Record of a pre-application meeting (PRR00036383)

Street number and name: 20 Melia Place & 43A Vipond Road
Suburb, town or locality: Stanmore Bay

The second pre-application meeting (held 7 May 2021) is to mainly to address the concerns raised from the first meeting particularly the following three main matters:

Figure 1: Overall Development Plan provided prior to the second meeting

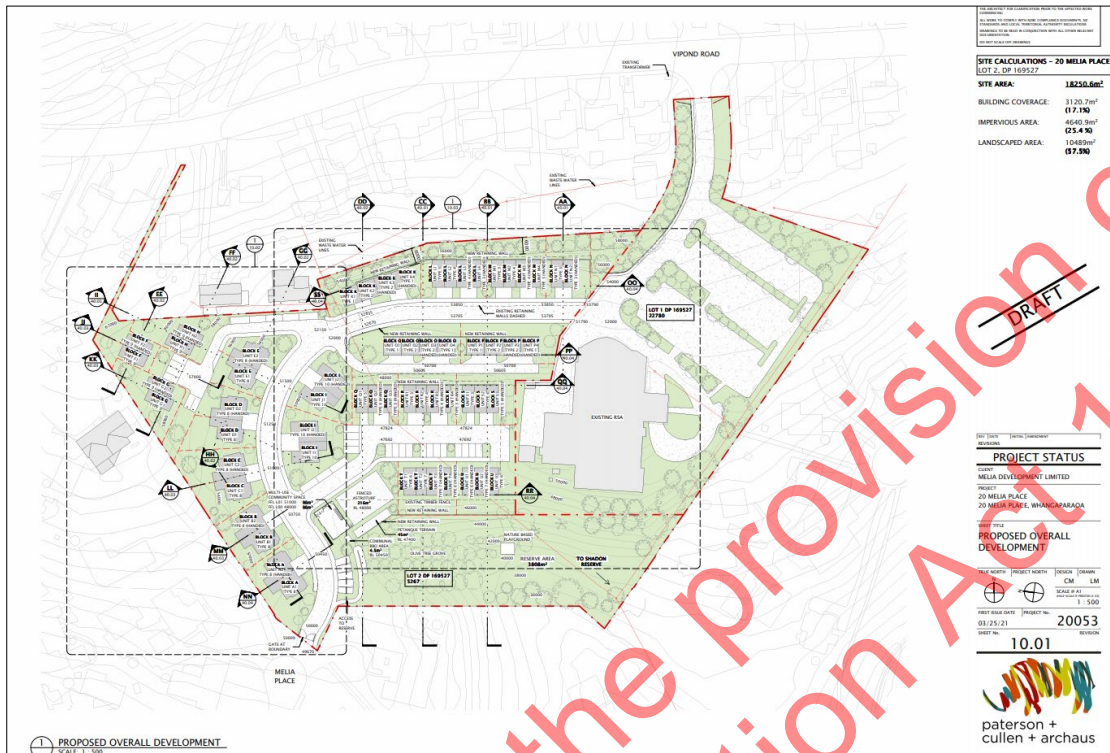
- The layout has changed to limit the length of the terraced buildings and introduce a duplex format mainly in two storey format. Where three storey buildings are proposed these are located in the parts of the site that can take advantage of the natural sloping landform. The duplex residential blocks are positioned centrally within the site.

- Reduction of the number of residential units from 72 to 59;
- Building coverage across the development site of approximately 20% with building height generally meeting the maximum building height of 8m with pitched roof up to 9m with cut.

- Detailed components of the community facility comprising of pavilion building, multi-use games area, BBQ area, olive grove and woodland for with nature-based playground. The community facility is located adjacent to the neighbouring Shadon Reserve. Through previous discussions, the community facility will be managed by a type of residents association and will not be vested.

7. **The layout**, on the whole, is generally successful and I appreciate topography will help mask the majority of development and its height/intensity from surrounding receptors.

27. Within the north section of attached housing a solution to help reduce bulk and density effects is to increase the separation between the blocks AND/OR intersperse the blocks with two story or break them all into duplexes.
